<b>Case ID - Case Name:</b>	20-1288-EL-BGN - New Market Solar
<b>Company Name:</b>	Hecate Energy Highland II, LLC
<b>Case Status:</b>	Facility Online
<b>Certificate Approved Date:</b>	March 18, 2021
<b>Facility Online Date:</b>	March 30, 2022
<b>Case Type:</b>	Solar Generation
<b>Capacity, Acreage:</b>	100.0 MW (24.0 MW currently operational), 1114 acres
<b>County(s):</b>	Highland

**Summary:**

### **Findings and Recommendations**

Map - B1

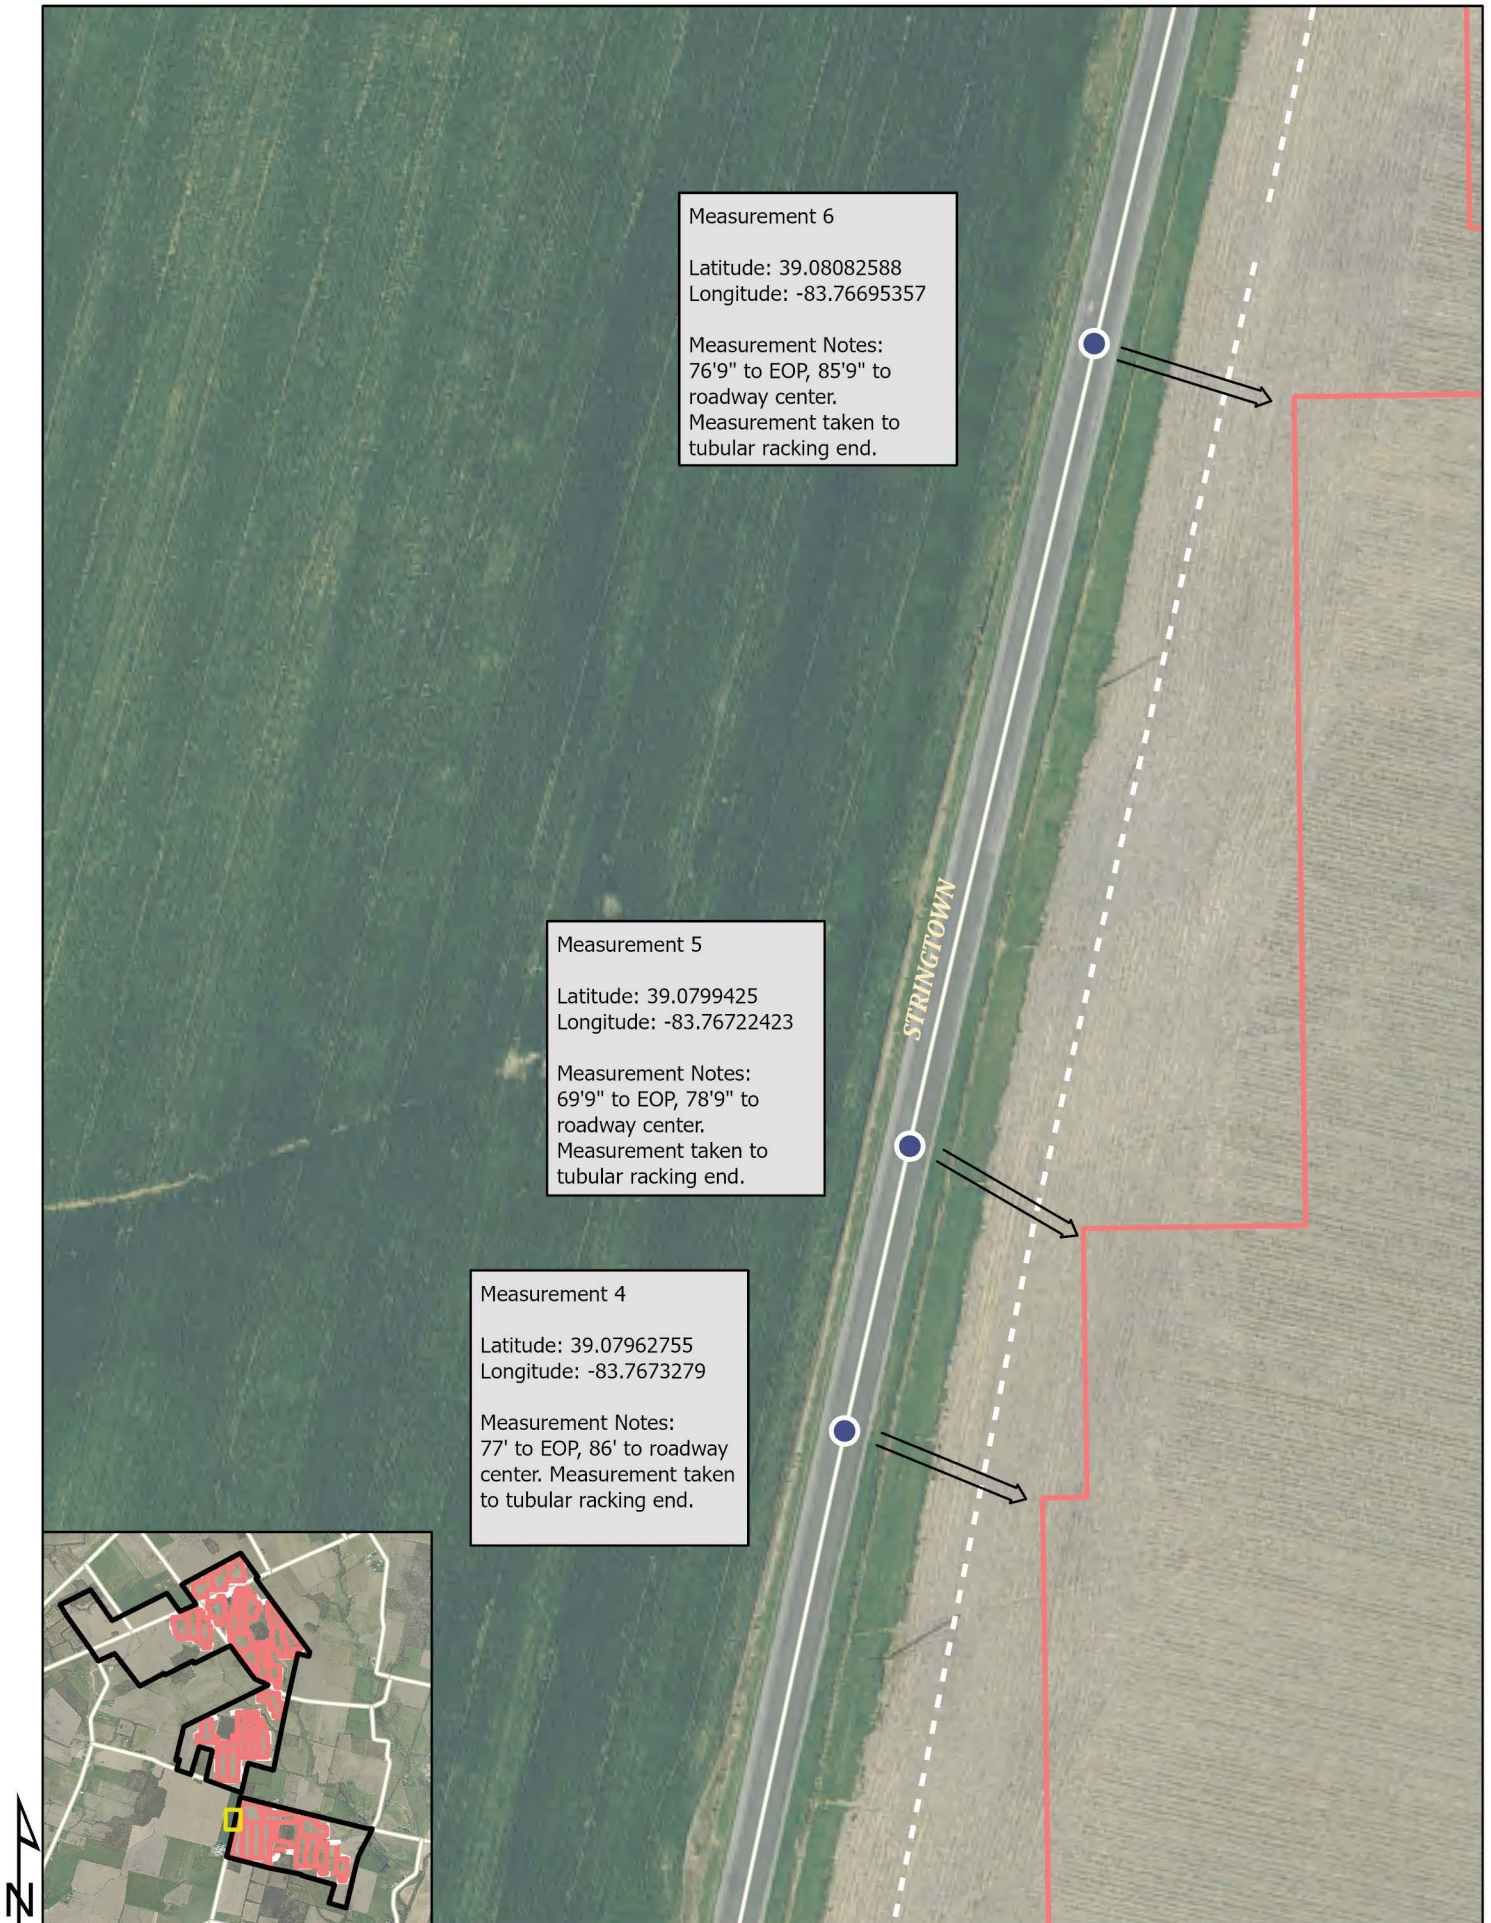
Measurement 8

Latitude: 39.08192058  
Longitude: -83.76660333

Measurement Notes:  
66'8" to EOP, 75'8" to  
roadway center.  
Measurement taken to  
tubular racking end.

Measurement 7

Latitude: 39.08162122  
Longitude: -83.76671417

Measurement Notes:  
76'7" to EOP, 85'7" to  
roadway center.  
Measurement taken to  
tubular racking end.

Measurement 9

Latitude: 39.08207943  
Longitude: -83.76389477

Measurement Notes:  
66'5" to EOP, 75'5" to  
roadway center.  
Measurement taken to  
tubular racking end.

Measurement 10

Latitude: 39.08177852  
Longitude: -83.7624339

Measurement Notes:  
67' to EOP, 76' to  
roadway center.  
Measurement taken to  
tubular racking end.

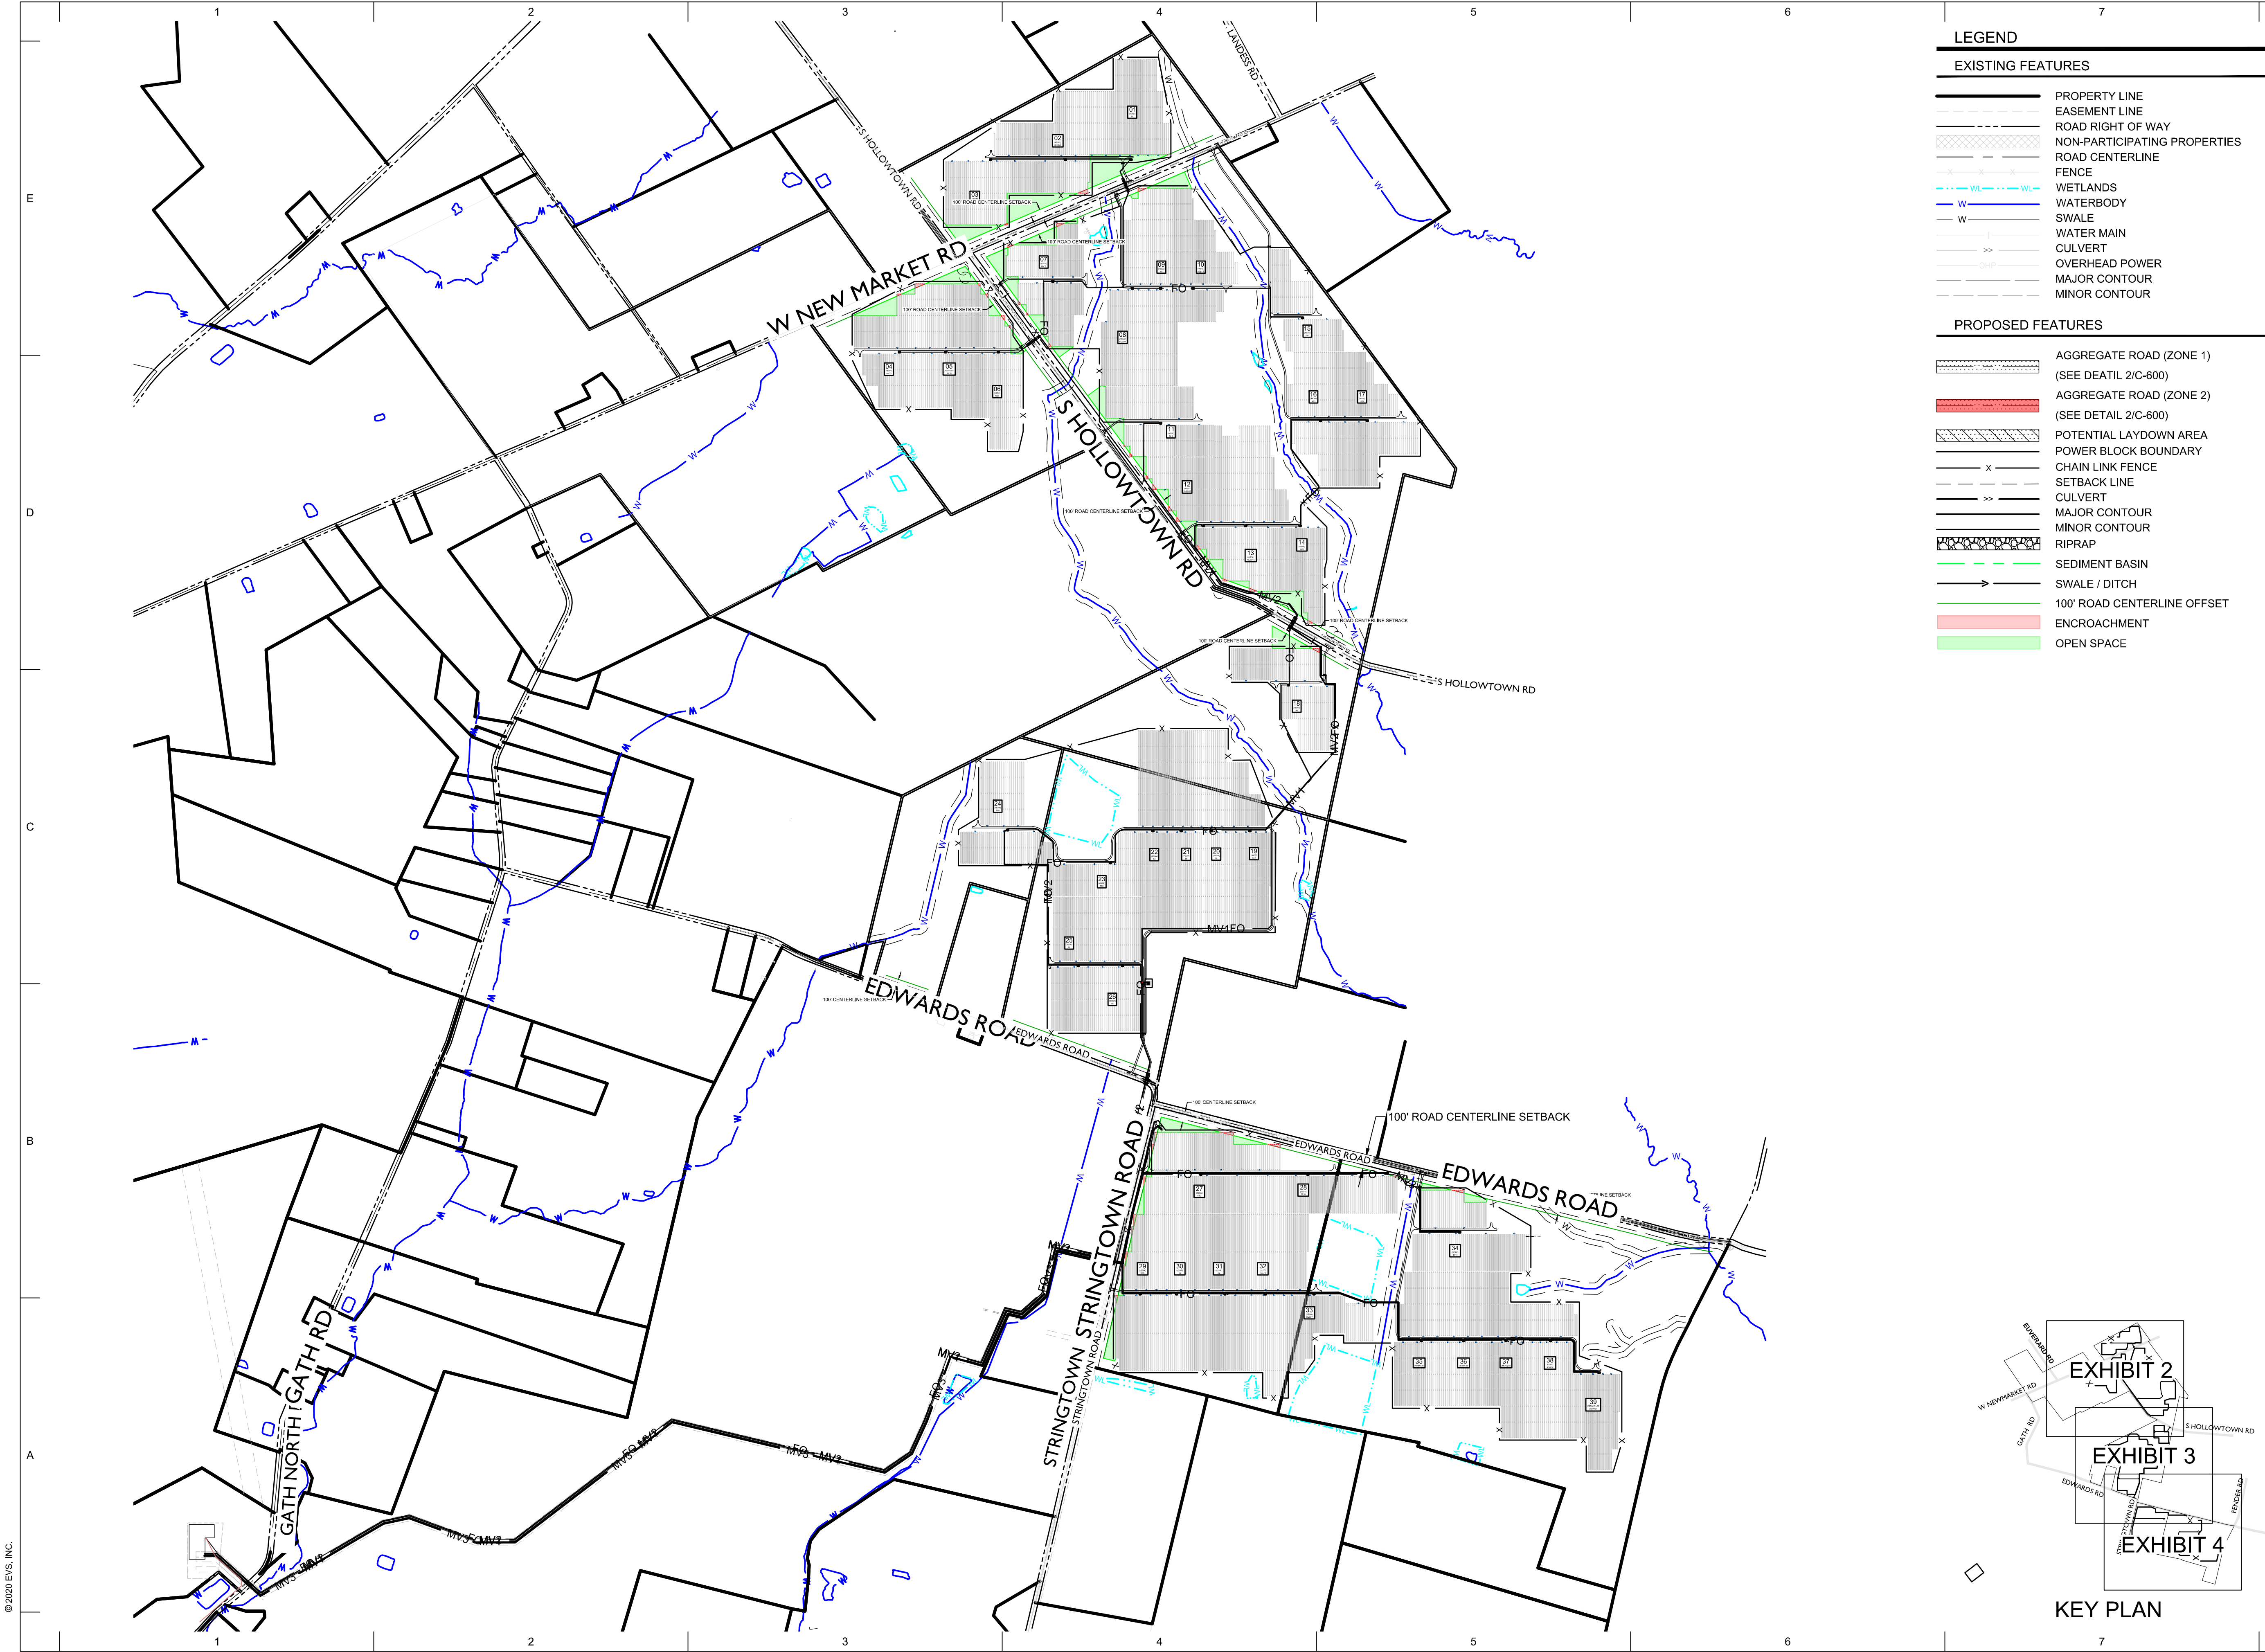
Lastly, you will find attached a site plan highlighting the ROW and Property Line areas where the Highland County Setback was utilized.
